Product Change Notification

Change Notification #: 111584 - 00
Change Title: Intel® Server System R1304BTLFANR, R1304BTLSHBNR and R1304BTSSFANR PCN 111584-00, Product Material Chassis' Modified to support AXXPRAIL
Date of Publication: August 08, 2012

Picture1:

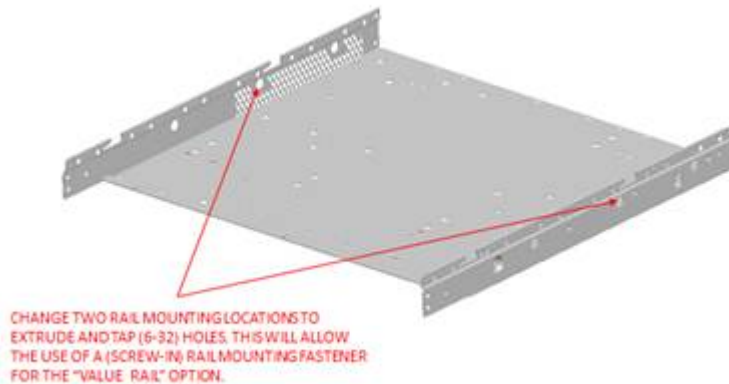
Relocating two rail mounting holes and extruding and tapping (6-32) them to allow support of the AXXPRAIL rail mounting brackets.

Please see Picture 1 and 2 for general and detailed views of the change.
